RE: 1422 Van Cleave Road NW
Grading and Drainage Plan
Stamp Date: 5/23/18
Hydrology File: G13D034

Based upon the information provided in your submittal received 05/25/18, the Grading and Drainage Plan **is not** approved for Building Permit. The following comments need to be addressed for approval of the above referenced project:

DRAINAGE AND GRADING PLAN

1422 VAN CLEAVE ROAD NW RESIDENCE

SHEET NO. C1

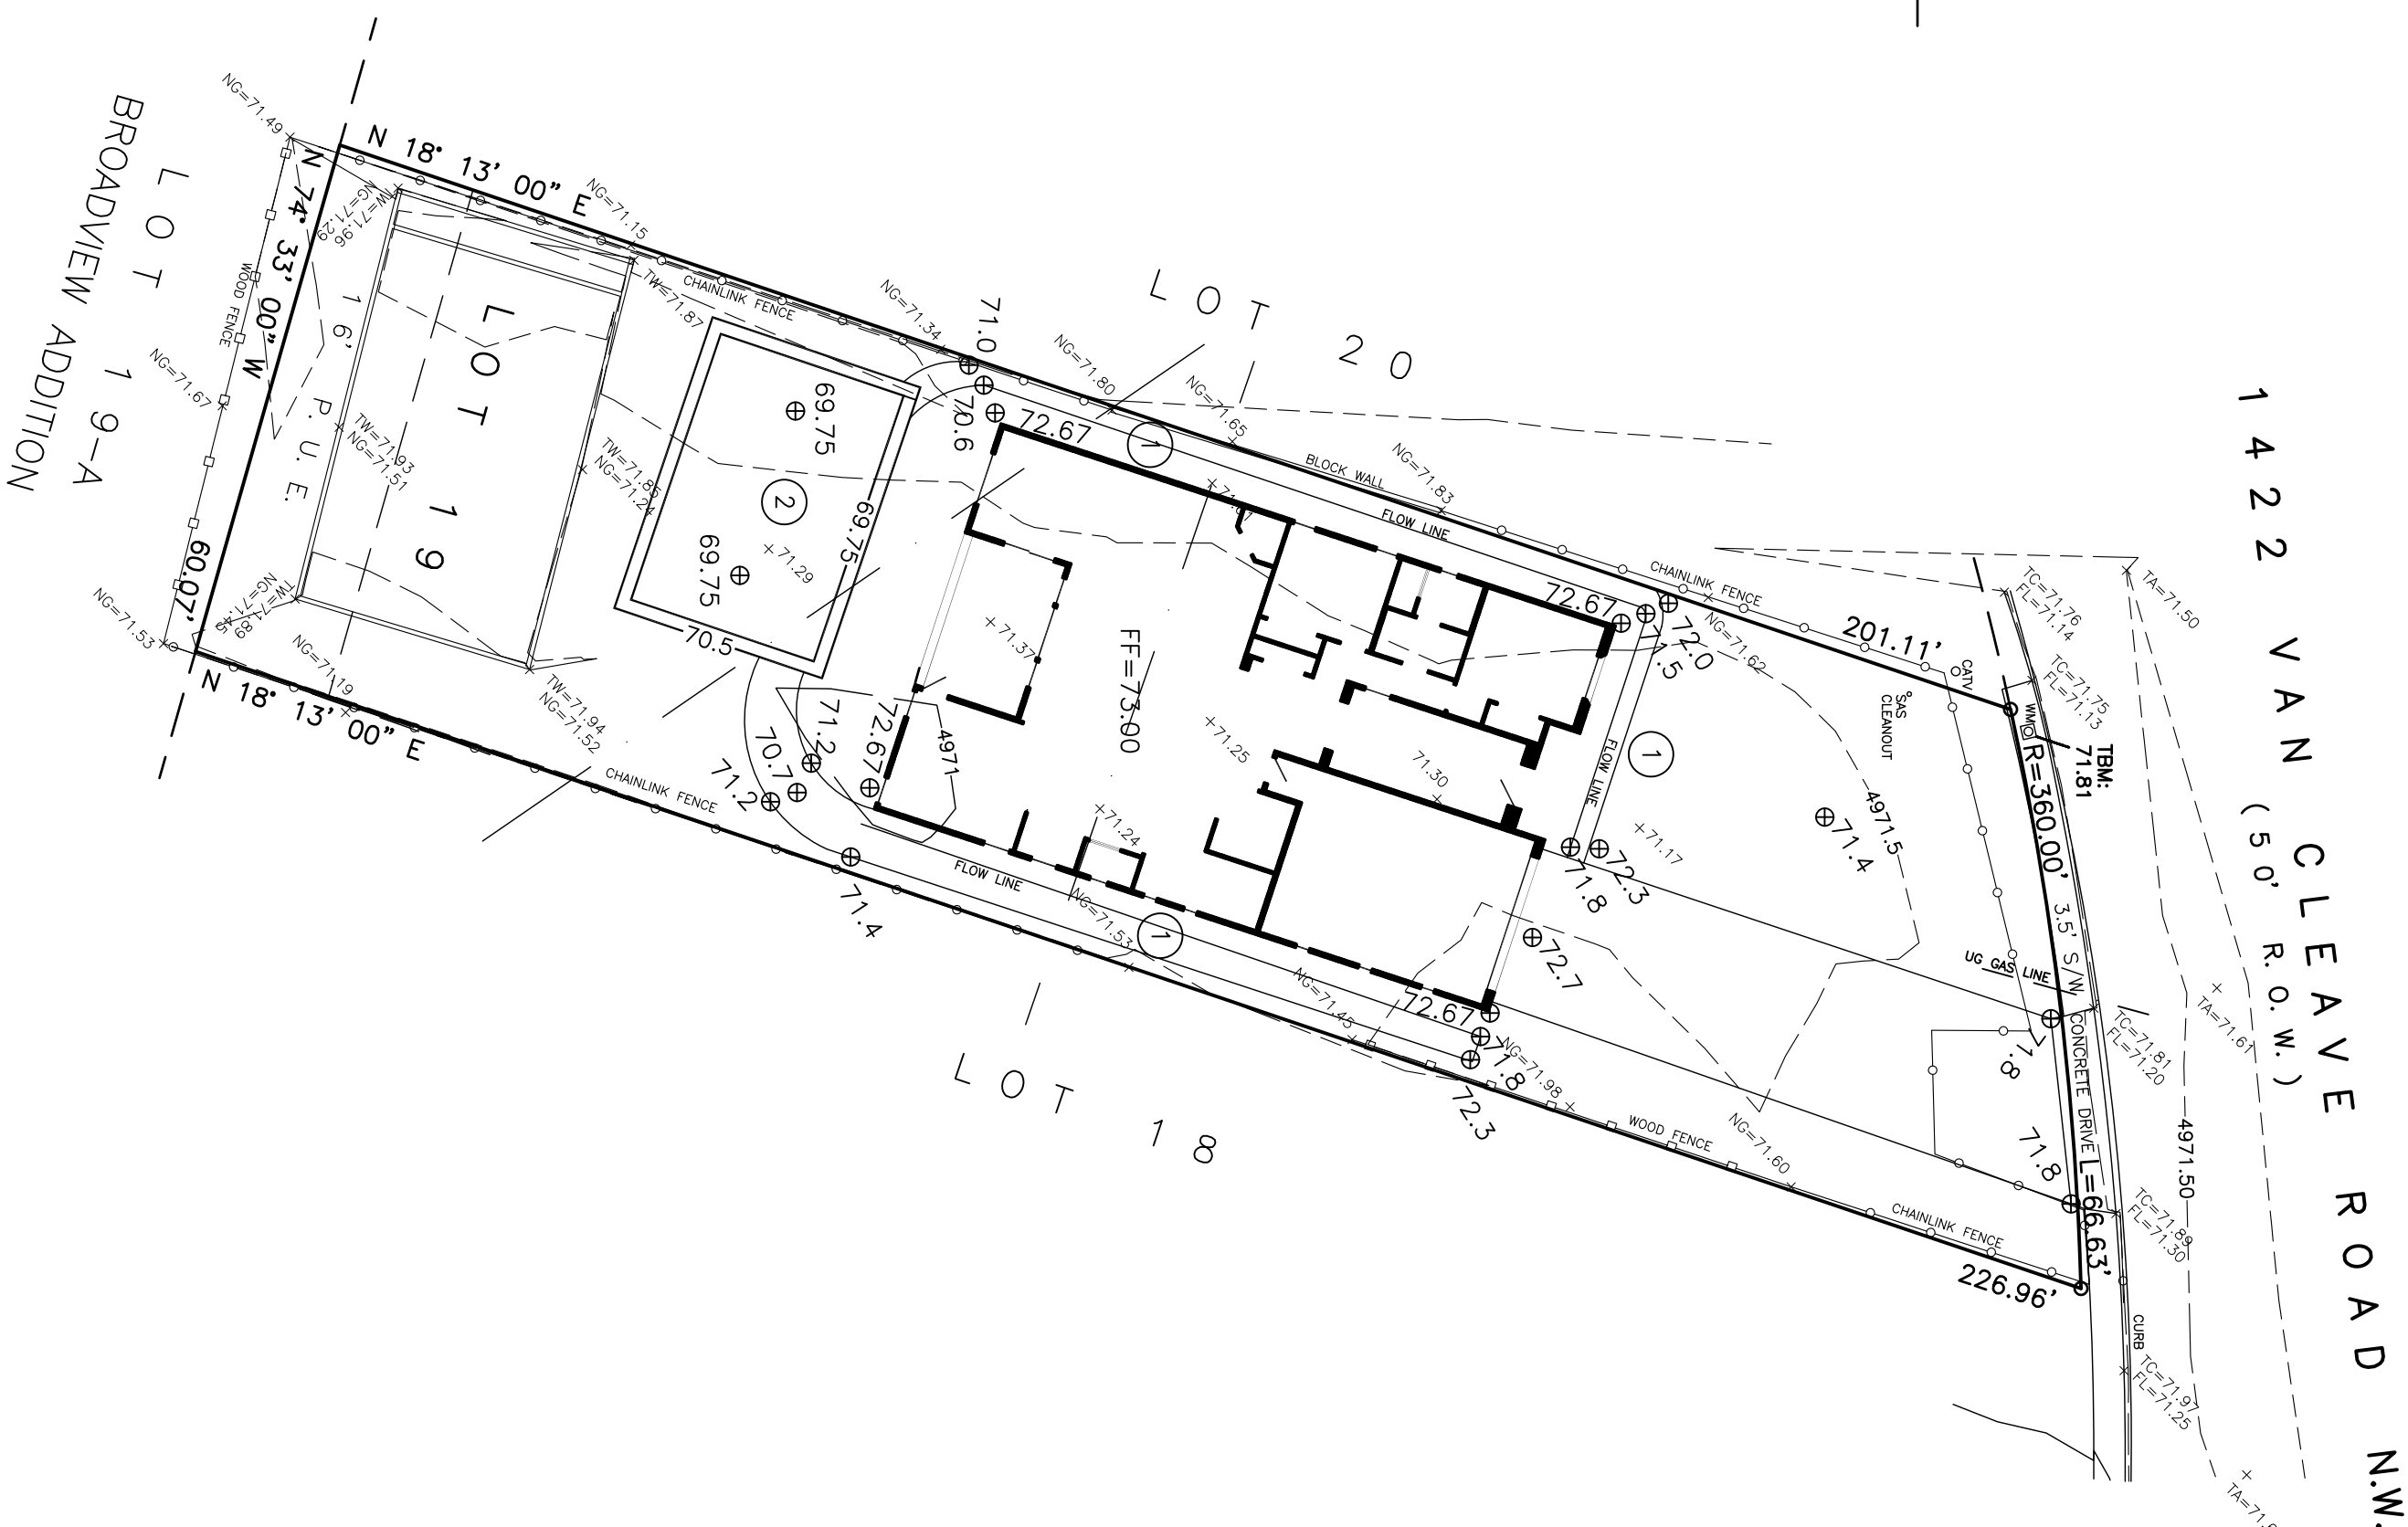
1. Please provide the FIRM Map and flood plain note with effective date. This site is in Zone "X" (Area with reduced flood risk due to levee) per FEMA FIRM Map 35043C2125D dated March 18, 2008. Please do not reference any other flood hazard maps since these are not accurate for flood insurance.

2. Since this site is in the Valley region and in Zone "X" (Area with reduced flood risk due to levee), please follow Chapter 22 Section 5.G (Flat Grading Scheme). The following conditions must be applied to the site:

- a. The maximum percent impervious of the lot and the contributing area may not be greater than 45%.
 - b. Pad elevation shall be a minimum of one (1) foot above the 100 year 10-day storm water surface elevation.

- c. The flow between the front yard and back yard cannot be obstructed. The storm water must be allowed to equalize to the same level between the front yard and back yard.

- d. A permanent perimeter wall or barrier around the development is required to contain the 100 year 24 hour storm developed runoff.
 - e. The high point of the street should be four inches above the 100 year 10-day storm water surface elevation.

Also a retention pond is required. The required volume = (3.67 in. X impervious area / (12in/ft)). The location with elevation of pond and the calculation of both the required and actual volume needs to be shown on the Grading Plan.
